ABINGTON TOWNSHIP

BOARD OF COMMISSIONERS
REGULAR PUBLIC MEETING

b. BOC-08-111424 Motion to approve LD-24-03 by LifeCycle Abington, 1329 Old York Road - Preliminary/Final Major Subdivision and Land Development plan and adopt Resolution #24-037.

SHEET 2 OF 10

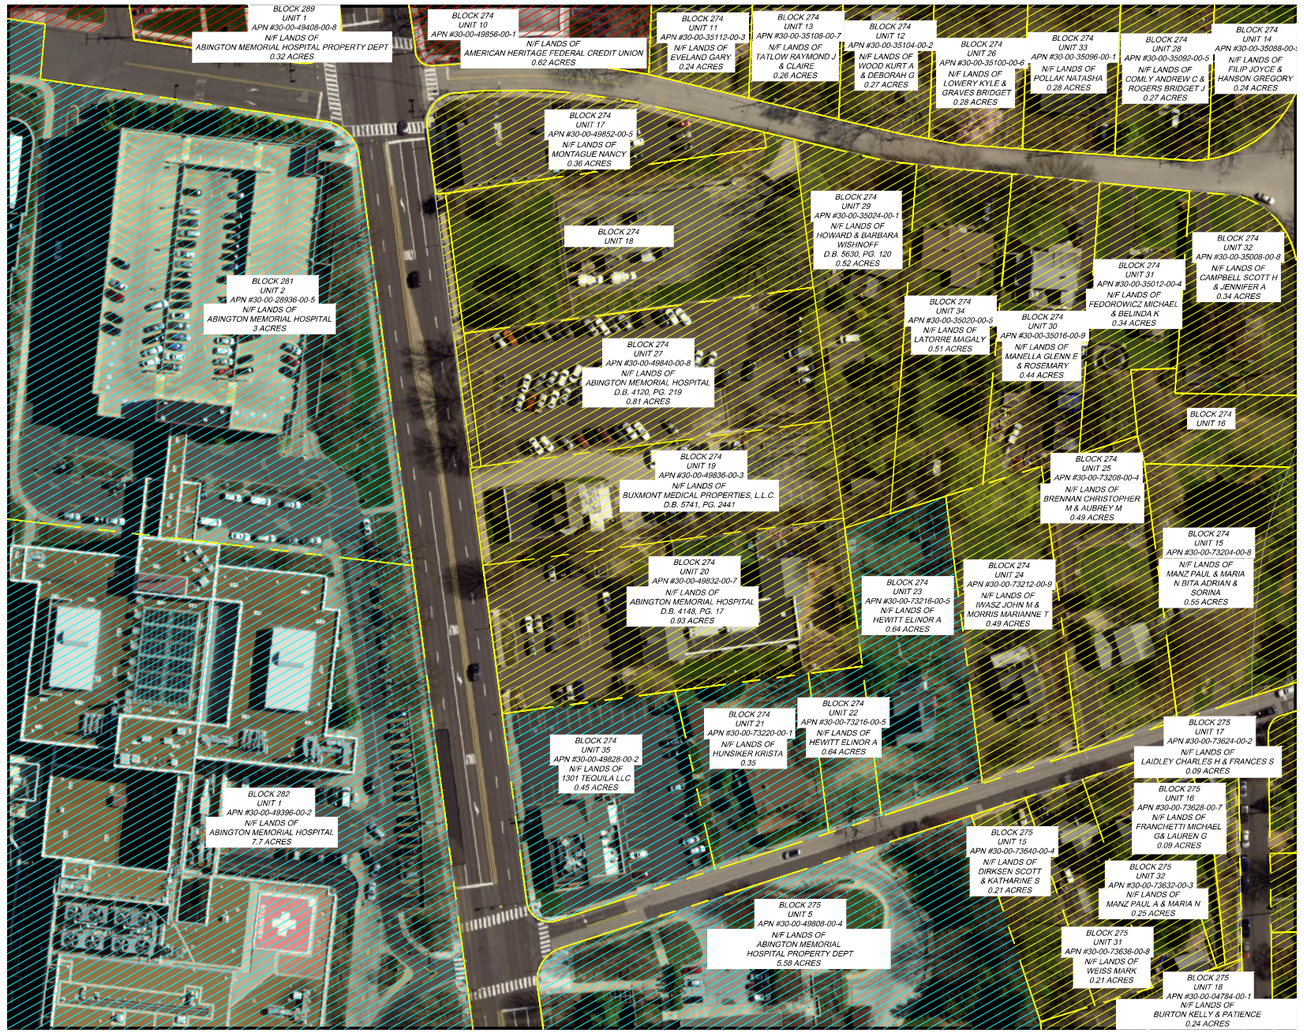
The Existing Conditions & Demolition Plan (Sheet 2) does not show any survey monuments and/or iron pins for the site. The plan shall be revised to show the existing survey monuments and/or iron pins. If no survey monuments or iron pins are found, new survey monuments and/or iron pins shall be provided under the proposed site conditions.

The soil types and associated soil information table have not been delineated on the Existing Conditions & Demolition Plan (Sheet 2). This information shall be provided on the plan; or the Applicant shall be required to obtain a waiver from this Code Section.

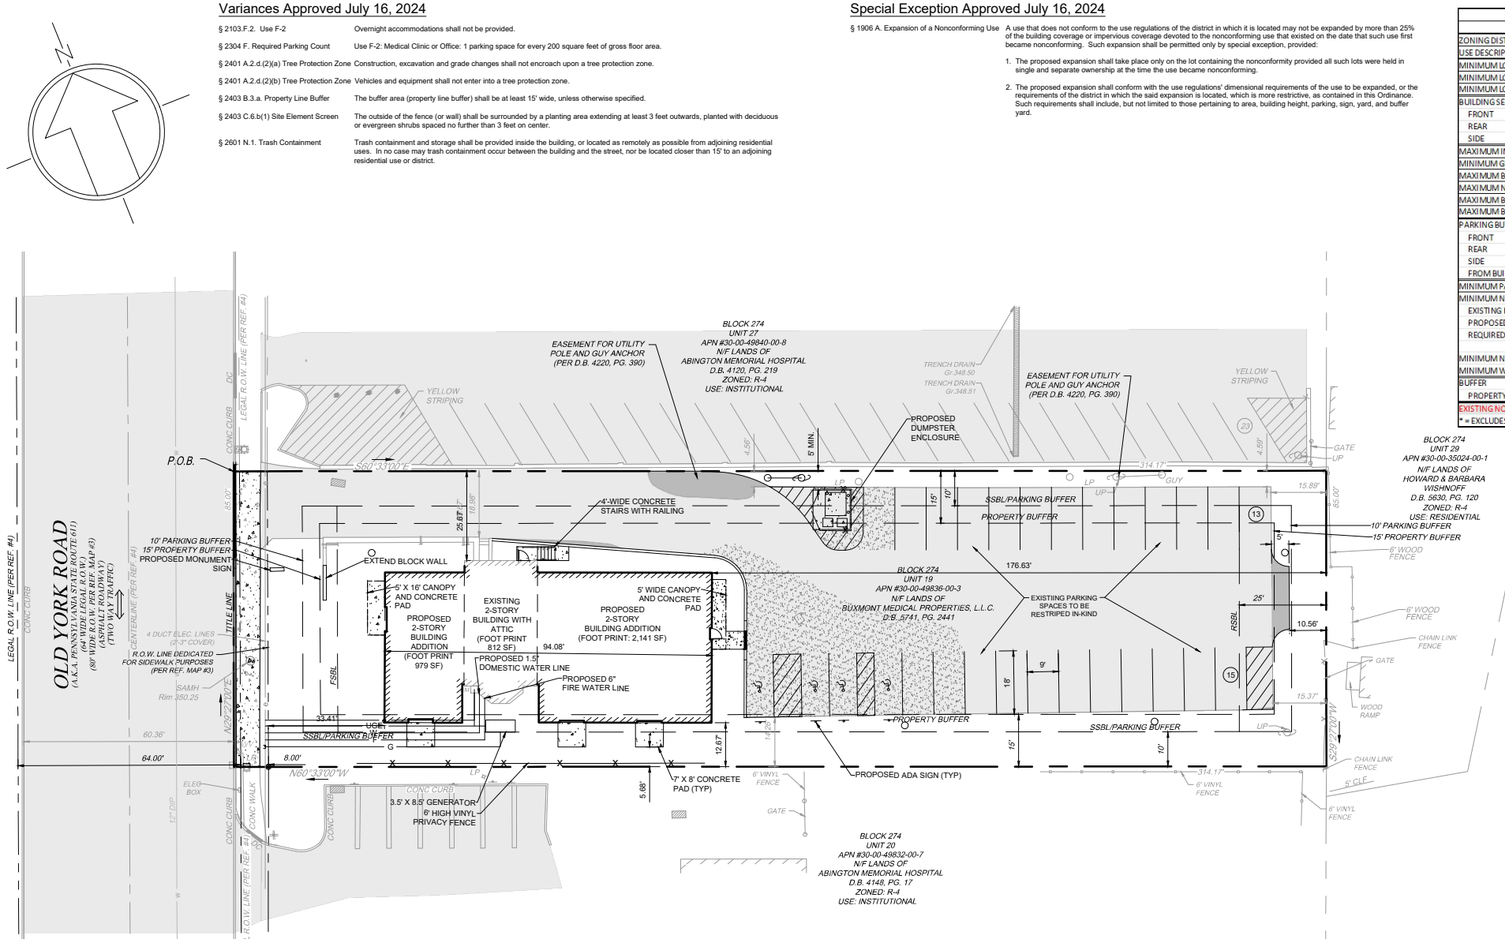
Based on the Zoning Data Table provided on the Land Development Plan (Sheet 4), the existing impervious coverage for the site is 66.66%, which is greater than the 55% maximum requirement, and is considered an existing non-conforming condition. With the proposed site improvements, the resulting impervious coverage for the site will be reduced to 66.43% which is still greater than the maximum impervious coverage requirement; however, the existing non-conforming impervious area is not increasing and would therefore be permitted to continue.

Based on the Zoning Data Table provided on the Land Development Plan (Sheet 4), the existing green area for the site is 33.34%, which is less than the 45% minimum requirement, and is considered an existing non-conforming condition. With the proposed site improvements, the resulting impervious coverage for the site will be increased to 33.57%, which his still less than the minimum green area requirement; however, the existing non-conforming green area is not decreasing and would therefore be permitted to continue.

As indicated in the Parking Reduction Summary Table provided on the Land Development Plan (Sheet 4), a parking reduction for the 200 feet proximity to a bus shelter was utilized in the parking space calculation. Based on our measurements, the nearest bus station is located at the corner of Old York Road and Keith Road, which is approximately 278 feet from the northern property line of the site, and is greater than the 200 feet maximum distance indicated in this Code Section. The Applicant shall clarify and confirm the distance from the nearest bus station. If the distance is greater than 200 feet, the 2% reduction pursuant to the above Code Section may not be utilized. Although the Applicant had obtained a variance from Section §2304.F.2 to allow fewer than the required number of parking spaces on the site, the Applicant will still be required to update the Parking Reduction Summary table accordingly to reflect the correct parking calculation and remove the reference to this section, as necessary.

As indicated in the Parking Reduction Summary Table provided on the Land Development Plan (Sheet 4), a reduction for the defined pedestrian walkway and bicycle trail systems was utilized in the parking space calculation. The site frontage along Old York Road has sidewalk that connects to the adjacent neighborhood residential developments and bicycle trail systems under the Township's Master Bike Plan; therefore, the Applicant may be permitted to claim the 3% reduction for this requirement.

DRAWN BY	MLS
CHECKED BY	MWW
DATE	08-01-2024
DRAWING No.	D 2427 01 01

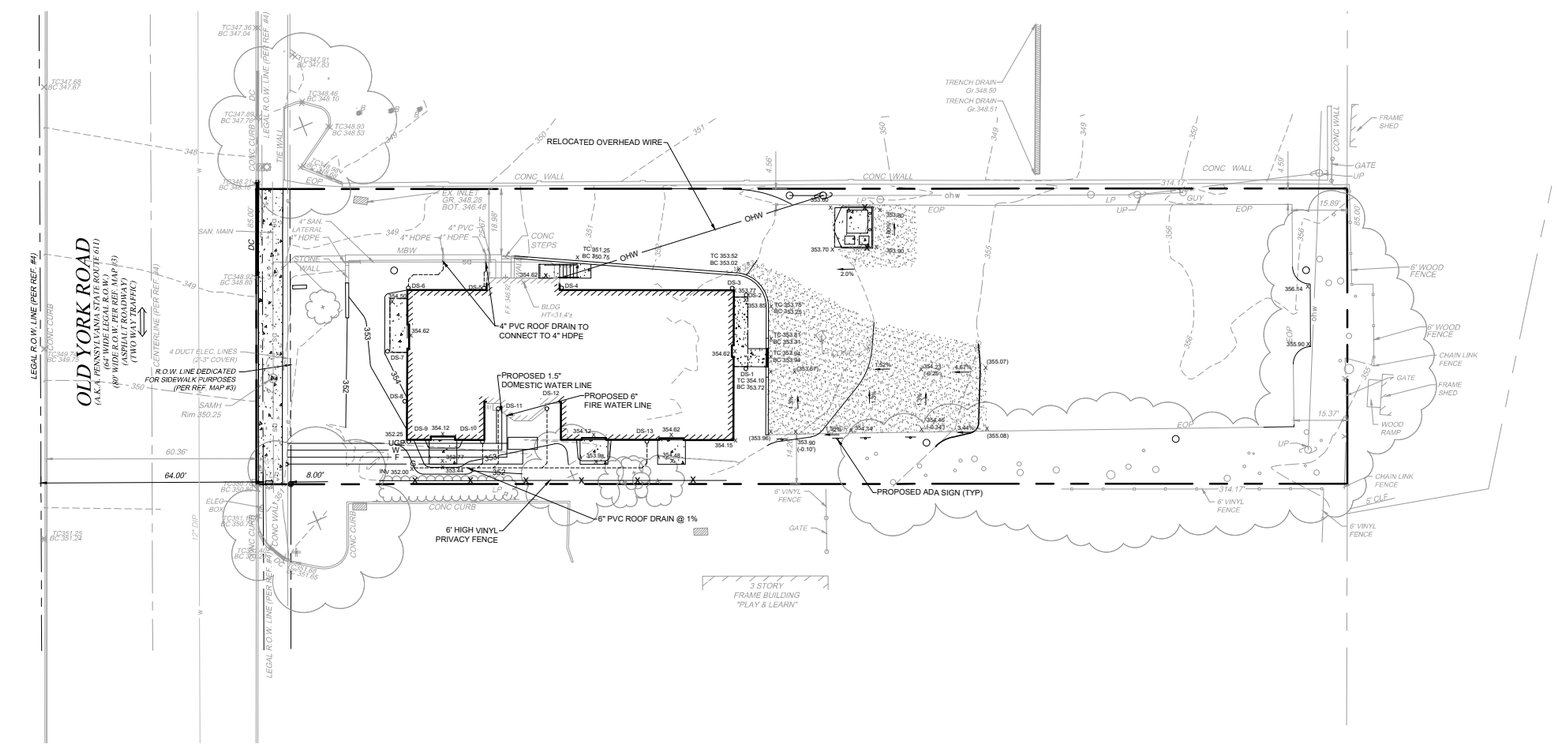
The required waivers request as noted above shall be added to the Land Development Plan (Sheet 3).

Sufficient room for the signature and seal of the Township Engineer shall be provided on the Land Development Plan (Sheet 3) to ensure no text overwrites with the adjacent MCPC signature block.

SHEET 6 OF 10

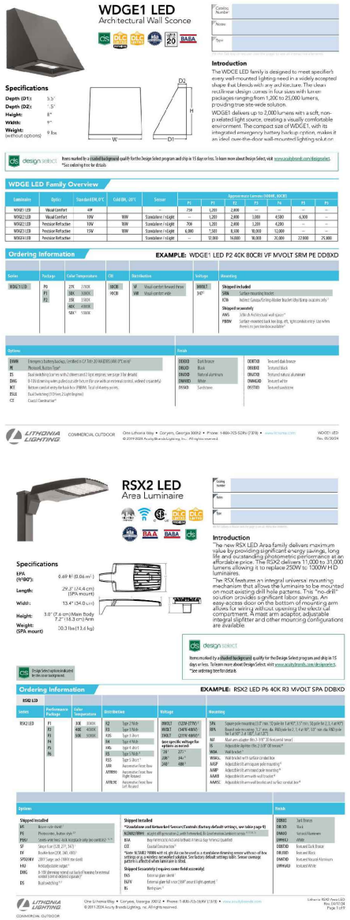
The Landscape Plan (Sheet 6) shall be prepared by a registered landscape architect. The signature and seal of the registered landscape architect shall be provided on the plans.
